Town of Maynard

January 13, 2026 Planning Board Meeting

2. Public Hearing - 151 Main Street (Continued From December 9, 2025)

Peer Review Comment Form

SITE DEVELOPMENT PLAN
FOR: MATTHEW HALL
SCALE: 1"=20' OCTOBER 9, 2025
REVISED: DEC 4, 2025

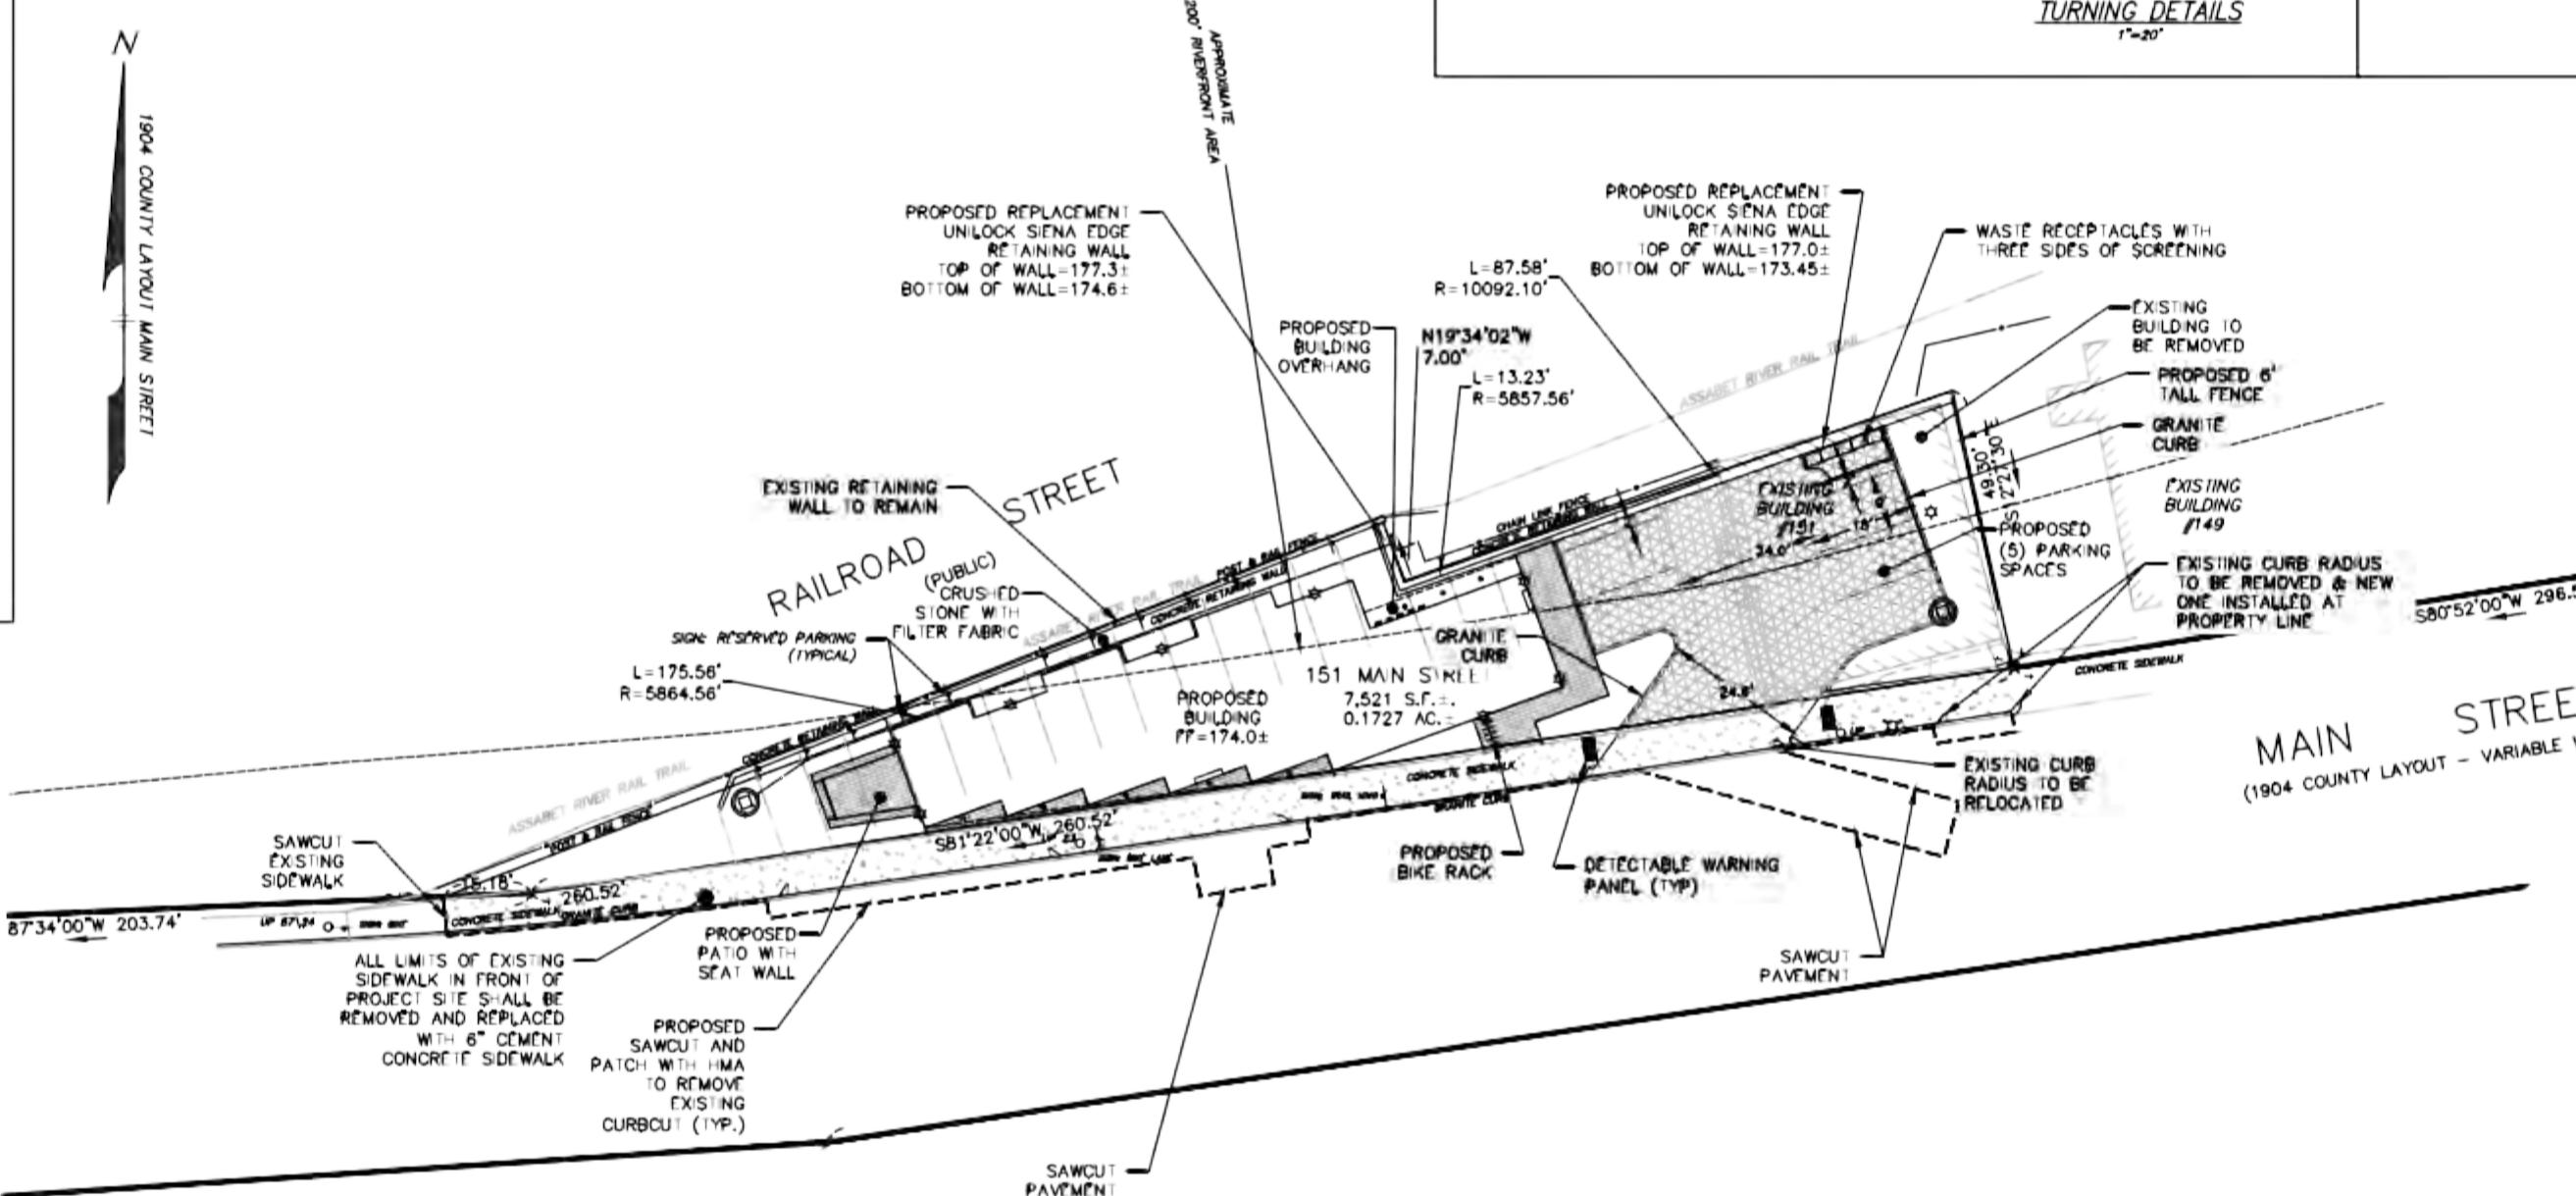
5	Site Development Plan		A cape cod berm and granite curb is proposed in the parking lot. A granite curb is recommended to hold up better against snow plows. Please consider revising.	All curbing is now proposed as granite.	VR	12/9/2025
6	Site Development Plan		It is recommended that the curb line on the eastern portion of the site moves the curb cut to the property line since the old curb cut for the garage door is no longer needed. Please consider revising.	The existing curb cut on the eastern portion of the site is now proposed to be moved to match the eastern edge of the frontage since there will be no garage there after this project is completed.	VR	12/9/2025
7	Site Development Plan		Is the existing wall being removed and replaced with a new wall or are the walls going to be next to each other? Any items to be removed should be called out on the plans. Proposed walls should be detailed on the plans with the existing walls if they are to remain. Please revise.	The rail trail retaining wall is to remain as is, and the other wall replaced with a unilock retaining wall. The labels for the walls have been updated.	JT	12/23/2025

(MIDDLESEX COUNTY)
LAYOUT PLAN
FOR: MATTHEW HALL
SCALE: 1"=20' OCTOBER 9, 2025
REVISED: DEC 1, 2025

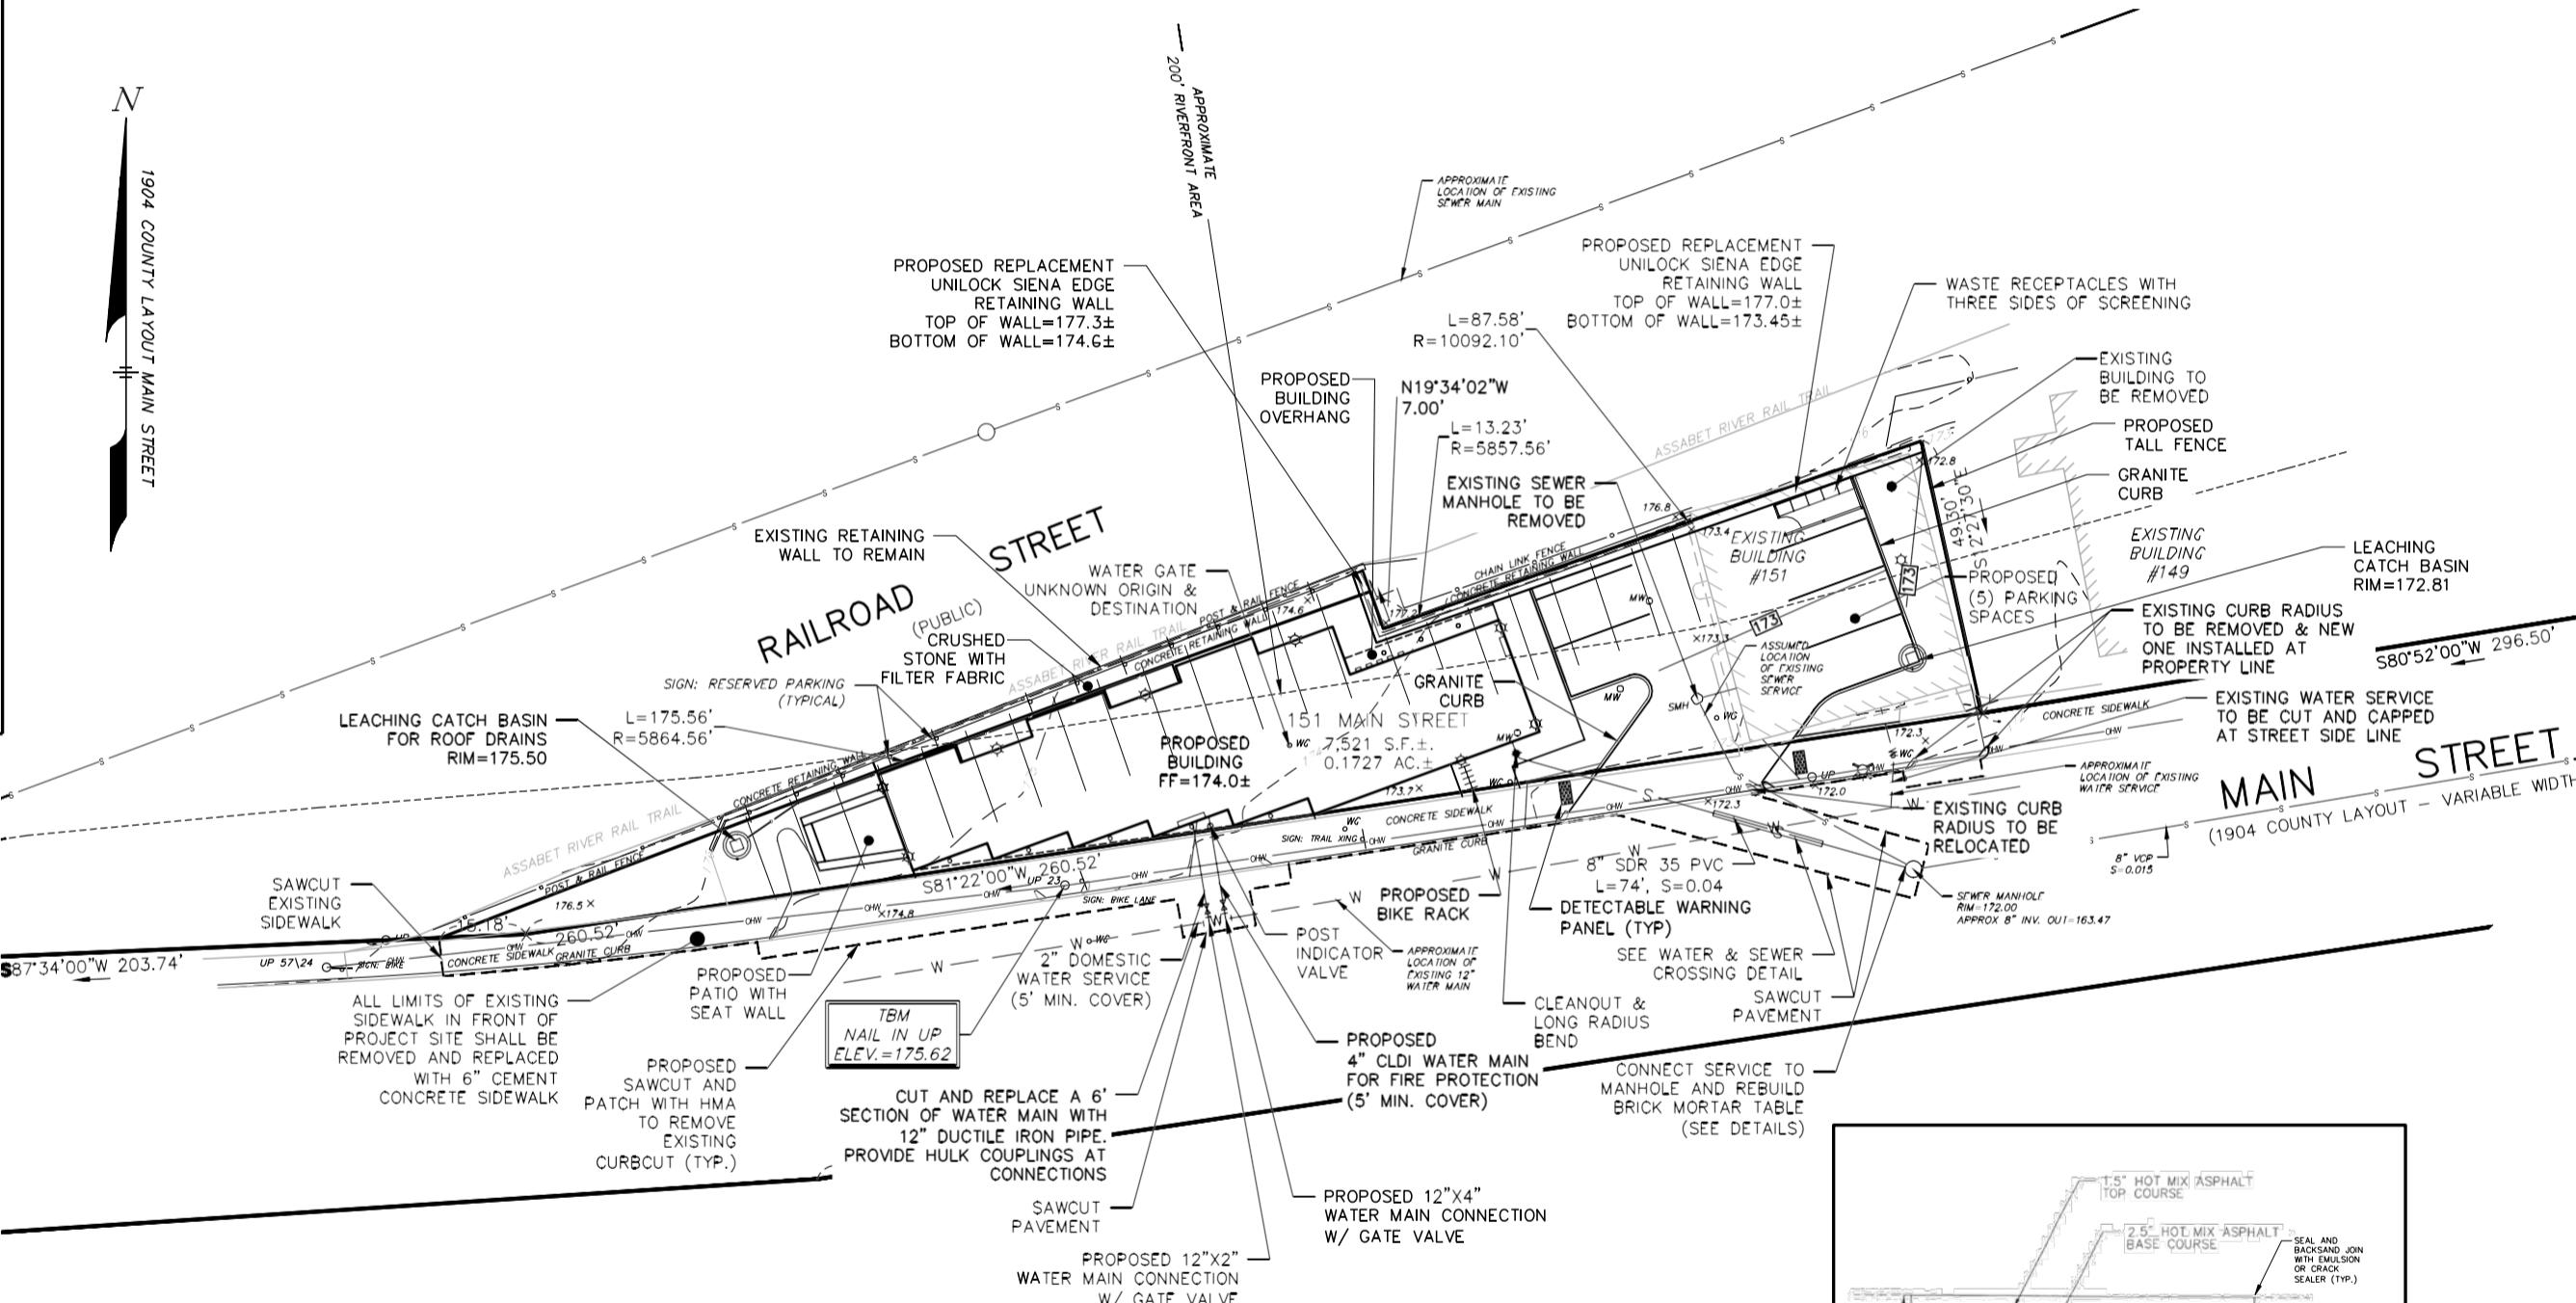
8	Layout Plan		Please clarify if all of the sidewalk south of the site will have vertical granite curb. There are several existing curb radii but only one is noted as being removed. The linework seems to indicate that there will be vertical granite curb. Is the sidewalk and curb along main street being replaced? Proposed grades shall be provided to confirm ADA compliance if the sidewalk will be removed. Saw cut lines shall be added to replace or reset the curb. Please revise.	All sidewalk along the frontage of the property will have vertical granite curb. All existing curb radii except the two for the proposed parking entrance shall be removed or relocated as shown on the plan. Per DPW, the entire sidewalk along the frontage is to be replaced. Sawcut lines added. Proposed spot grades have been added.	JT	12/23/2025
9	Layout Plan		Please confirm why the driveway entrance is angled promoting a left turn entry over a right turn entry. Please provide turning movements to confirm cars can turn right into the parking lot.	Driveway entrance is proposed to maintain existing curb cut and avoid existing fire hydrant and utility pole. Turning simulations are now provided in a detail.	VR	12/9/2025

10	Layout Plan	Zoning bylaws 6.1.10	Per 6.1.10, no parking space or other paved surface other than access driveway shall be located within 20 feet of the front lot line or within 10 feet of any other lot line. The project does not meet these thresholds. Will a waiver be requested for this regulation?	A waiver is requested for the on-site parking.		
10A	Layout Plan	Zoning bylaws 6.1.10	We defer to the Board for approval.			
11	Layout Plan	9.4.6 Special Permit Criteria	The proposed development should provide significant improvements to the parking in the downtown area. There is currently only parking for the residents and not for the people visiting or for employees. The parking on the street is two hour metered parking which does not support employees. Please explain where employees will park. Will this be met by a separate lot per 9.4.8.1?	A waiver is requested for the on-site parking. Employees will park in public lots.

11A	Layout Plan	9.4.6 Special Permit Criteria	We defer to the Board for approval.			
12	Layout Plan	PB Rules & Regs H.10	Snow storage is not identified on the plans. Please confirm how snow will be handled?	Snow will be stored in the newly introduced green spaces around the parking area. Any excess snow will be removed from the site.	JT	12/23/2025
13	Layout Plan	ADA	Per ADA parking requirements for parking lots with 1 to 25 parking spaces a minimum number of 1 accessible parking space is required. In the Planning Board Hearing, it was mentioned that ADA parking was not required by the applicant. Please provide back up documentation describing the exemption. Will any units provide ADA mobility features?	Per Section 6.1.12 of Maynard's Zoning Bylaw, a handicapped parking space is only required once the total number of spaces reaches 6. Per 521 CMR 23.2.1 of the Architectural Access Board, an accessible space is only required when the total parking in the lot reaches 15 spaces. The proposed parking area only has 5 spaces.	VR	12/9/2025

WATER POLLUTION PREVENTION PLAN
MATTHEW HALL
OCTOBER 9, 2025
1"=20'
REVISED: DEC 4, 2025

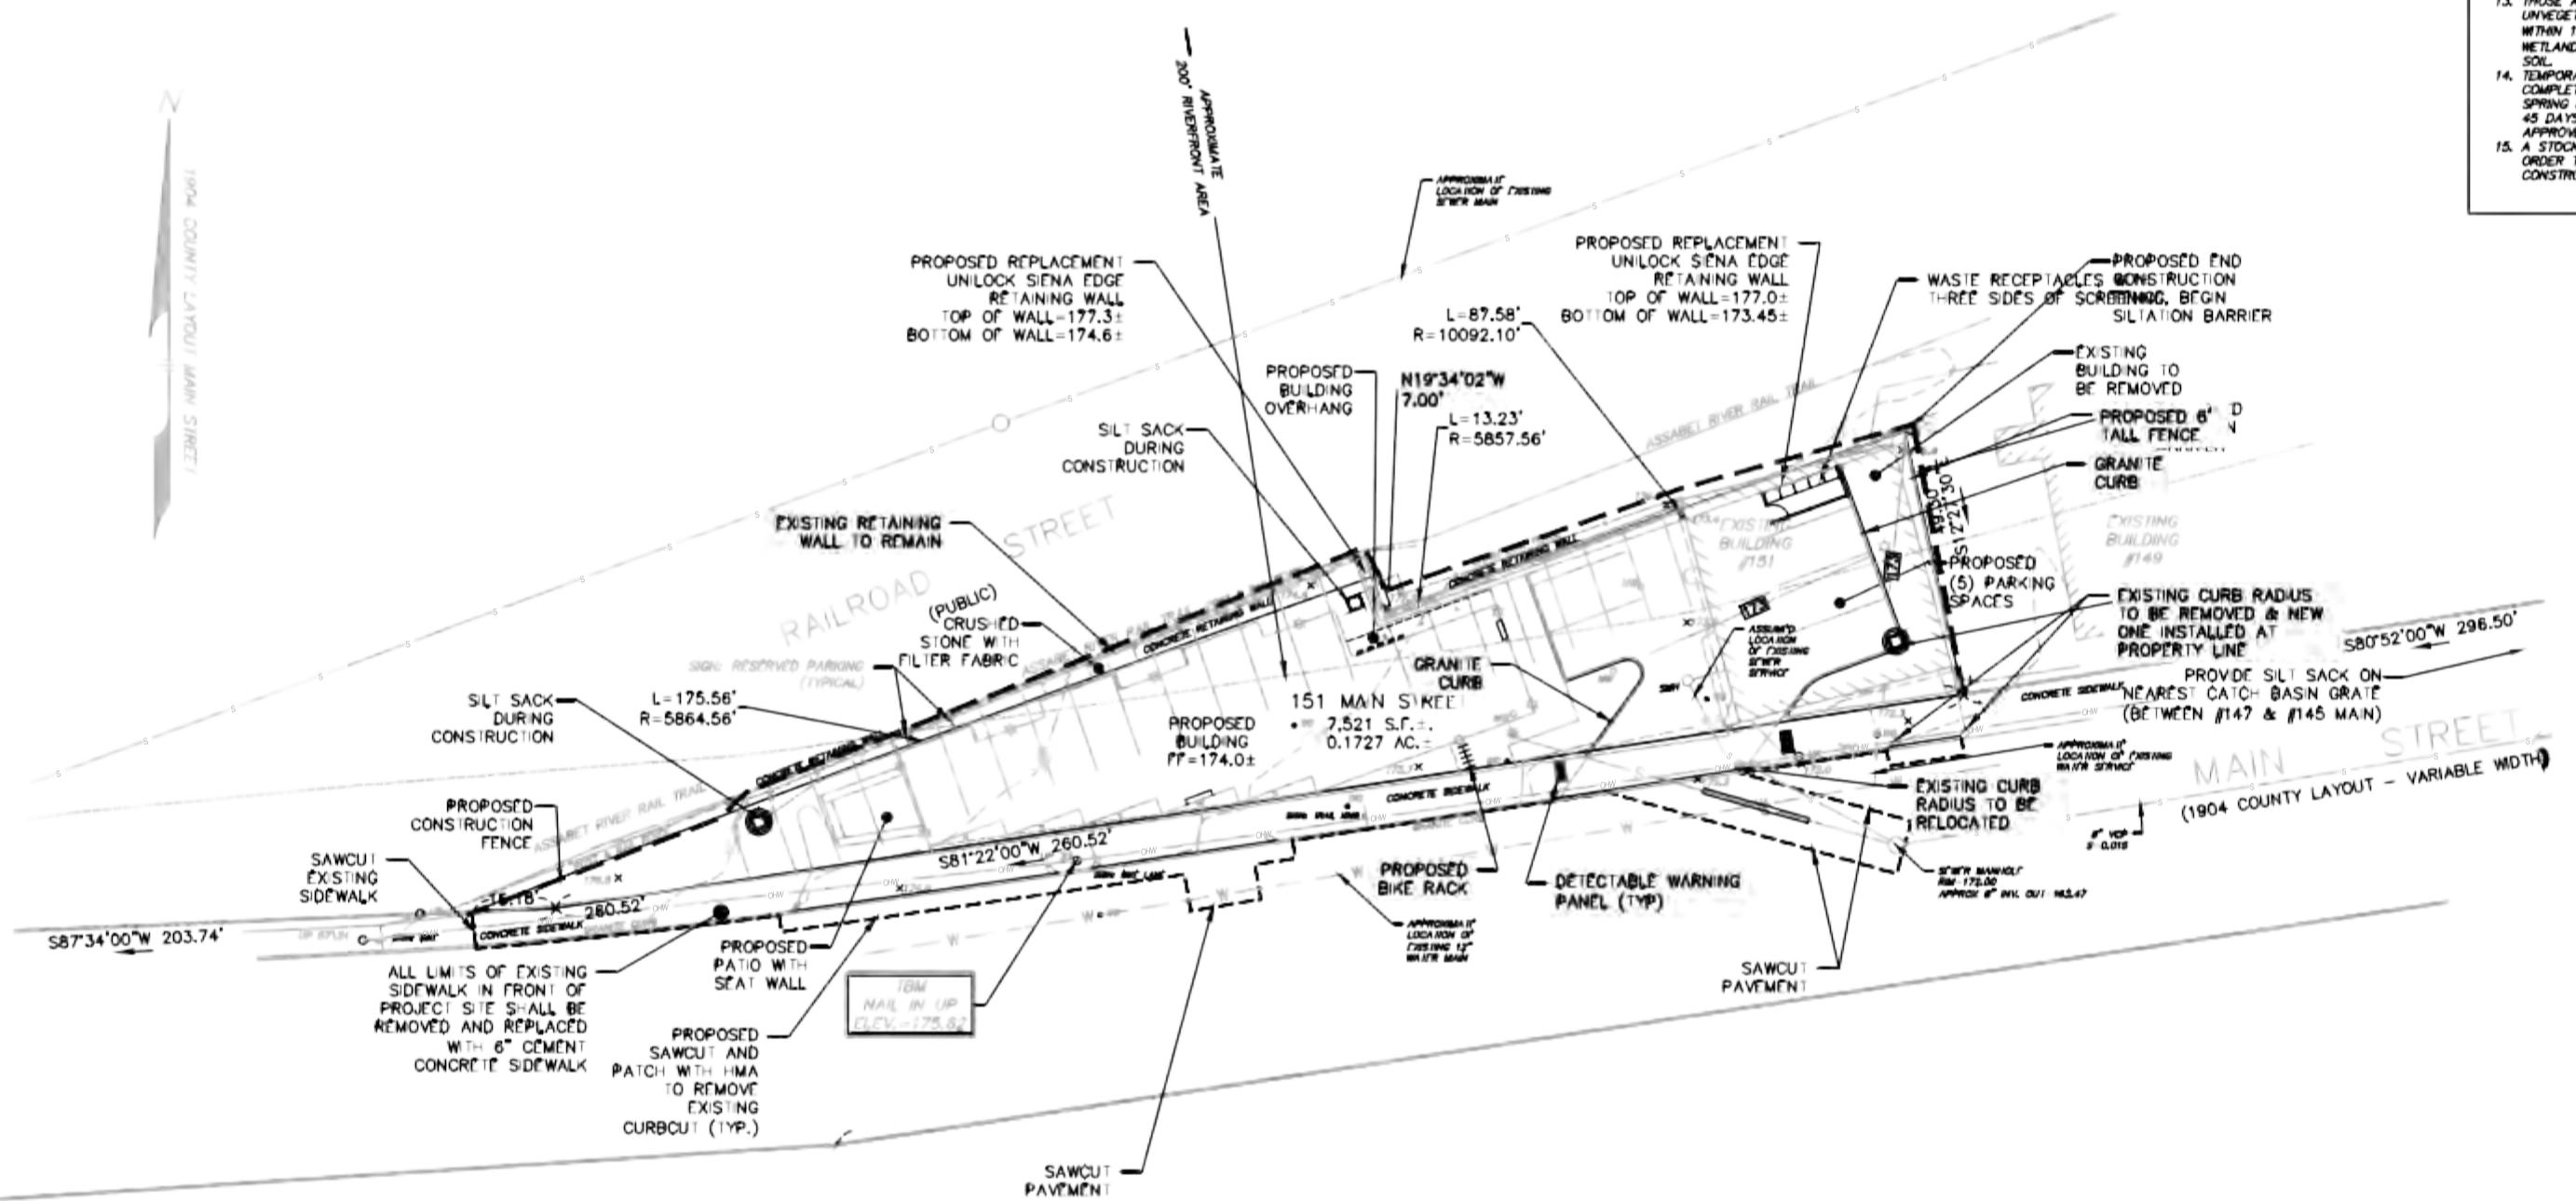
23	Stormwater Pollution Prevention Plan		Straw waddles or compost filter tubes are recommended to be used in conjunction with the siltation fence. Please consider revising.	A compost filled tube (filtermitt) detail is now provided on Sheet 6.	VR	12/10/2025
24	Landscape Plan	PB Landscape Regs 4.4	Please provide a landscape maintenance plan.	Provided by Landscape Architect	JR	12/8/2025
25	Landscape Plan	PB Landscape Regs 4.4.2	Provide Irrigation Design and product cut sheets if irrigation is proposed.	None Proposed	JR	12/8/2025
26	Landscape Plan	PB Landscape Regs 5.6.2	The required planted buffer between parking lot and 149 Main Street consists of ornamental grasses, a tree, and a large shrub. Maintained ornamental grasses are cut back annually and will not provide screening for some of the year. The design will not meet the buffer requirement of six foot height at installation or the ten foot width. Please revise.	We had proposed a 6' fence but it was not clearly labeled.	JR	12/8/2025
